Official Transcript of Proceedings
NUCLEAR REGULATORY COMMISSION

Title: Advisory Committee on Reactor Safeguards
 APR1400 Subcommittee

Date: March 22, 2017

APR1400 SUBCOMMITTEE

6.3.2 System Design

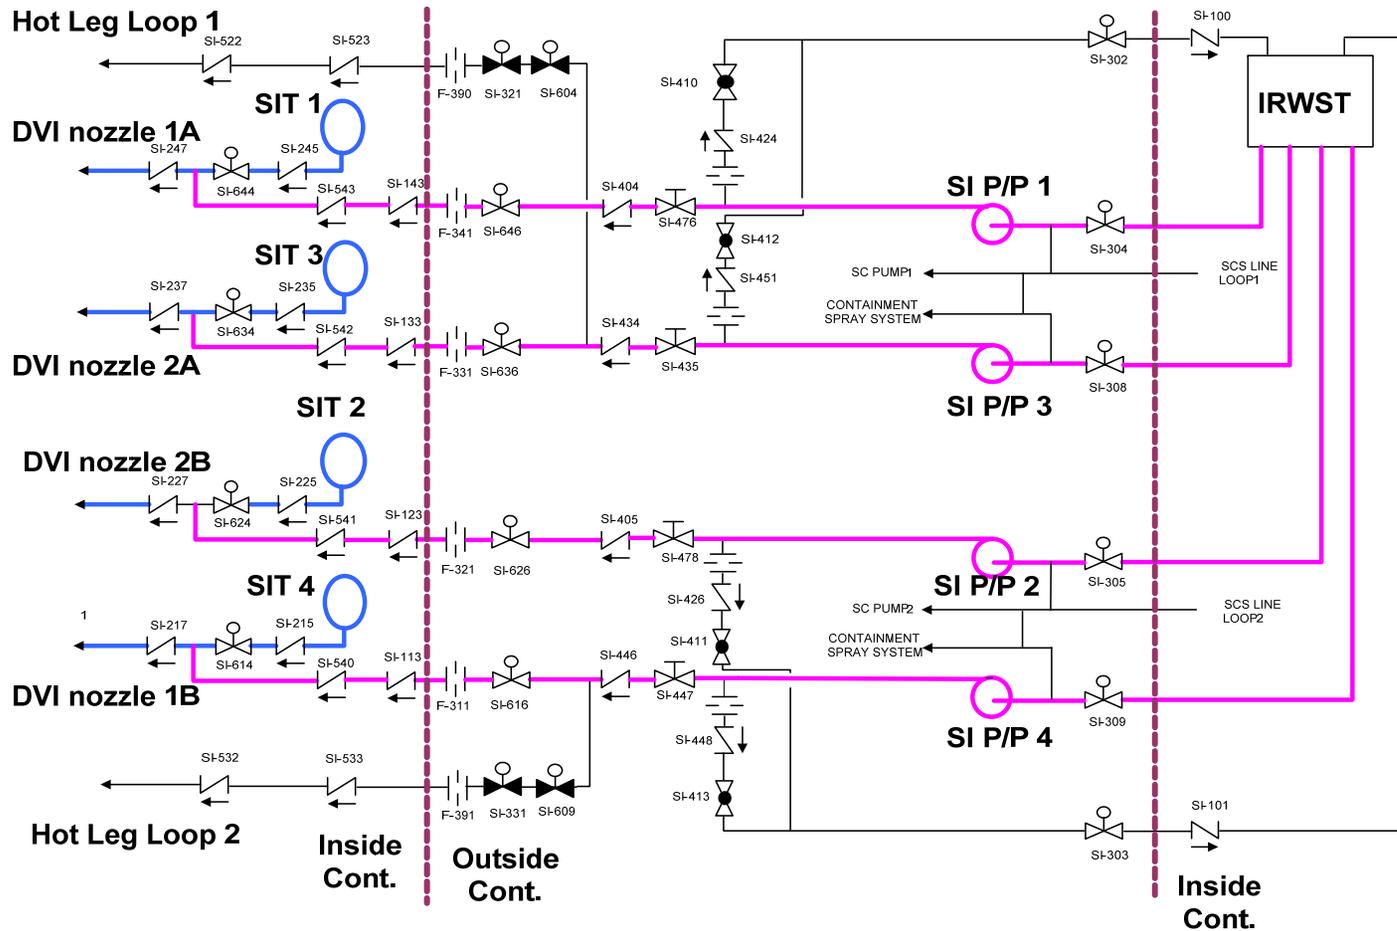
MEMBER STETKAR: Can you go back to the drawing on slide 26 that shows the -- there you go.

This drawing -- we had a discussion earlier about hydrogen control -- this drawing does not show the three-way valve to the IRWST from the POSRVs. That's a factual statement. That is not a question.

MEMBER STETKAR: But I just wanted to do -- the three-way valve, it is my understanding that under severe accident conditions, as indicated by high core exit temperature -- and I do not remember the value -- the operators are instructed to open the POSRVs and align the three-way valves to blow down into the steam generator compartment. Is that correct?

6.8 In-containment Water Storage System

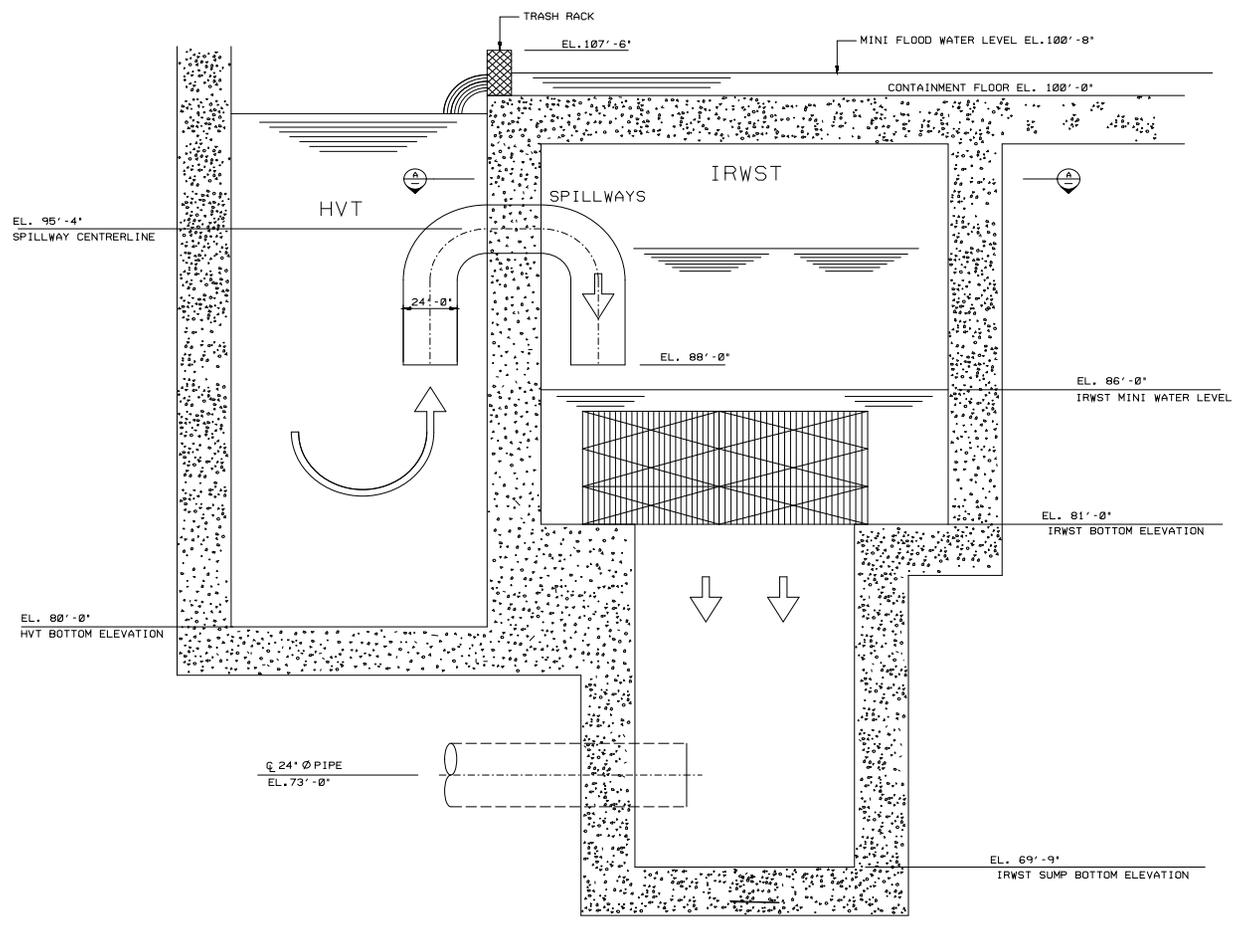
MEMBER CORRADINI: So, I had a question that maybe I just don't understand. No, you can go to the slide, the cartoon, your next slide.

So, there is a thing noted in the SE about swing panels to protect against pressure transients. What is a swing panel and where is it? I couldn't figure that out.

MEMBER CORRADINI: Okay. So, let me ask my question differently. Why even have a swing panel at all? Why do you need a blockage there? What's the reason for even having a panel? Why isn't it just open communication?

MEMBER CORRADINI: Okay. So, my second question is, the strainers to clean up the debris are sitting inside the IRWST. So, the HVT just collects stuff by gravitational settling and, then, that U-bend, essentially, then transports the water over before it is strained out?

MEMBER STETKAR: Wait a minute. I read that there are screens in the HVT because I know the low-power and shutdown PRA models explicitly say that those screens are covered to prevent debris from entering the HVT during shutdown work inside the containment. So, one thing is wrong, either your statement or what's assumed in the PRA. The question is, are there screens for the HVT?

MR. YOON: But the screens in this. This figure is the pressure. First, the debris is screened at this point.

I do want to just help a little bit. There are two areas in the DCD that I want to reference you to. The swing panels are described in Subsection 6.8.2.2.5, and you can get a discussion on it there. And as stated in the DCD, the swing panels are closed to minimize the release of IRWST water into the containment atmosphere during normal operating plant operations. So, you want to be able to have the pressure released, but you don't want the water to be disappearing from your IRWST during normal operation.
